**66309D-06**

# S E R V I C E N O T E

## Agilent 66309D DC Power Supply

**On faster computers, when programming over GPIB, a random error will occur.**

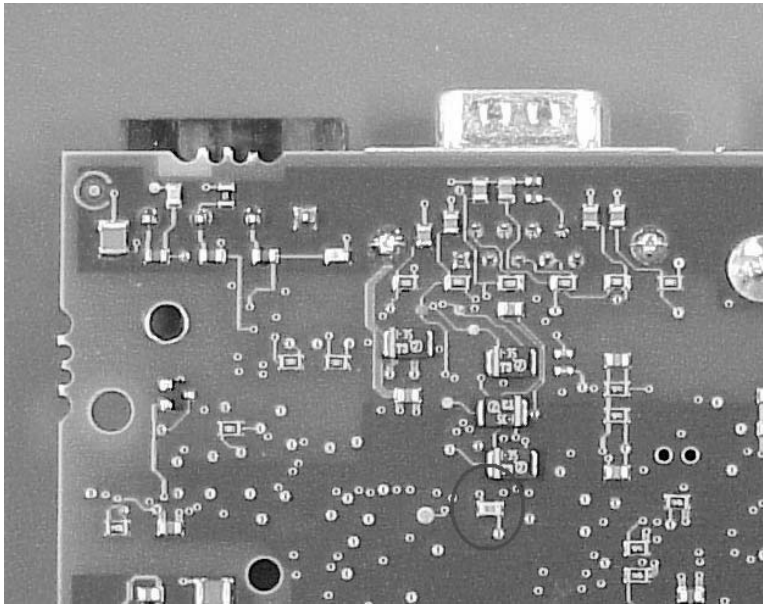
When programming a unit over GPIB, a random error -113 (“Undefined header”) will appear on the unit. This error can be read back via the front panel or over the GPIB bus.

Change resistor R1246 (see picture for location) from 511 Ohms to 100 Ohms (part number 0699-3058). This requires soldering a surface mount component and can be very difficult. This does not require re-calibration.

Replace the entire GPIB assembly (part number 5063-4841) with a newer one that has the 100 Ohm resistor. This will require the unit to be re-calibrated.
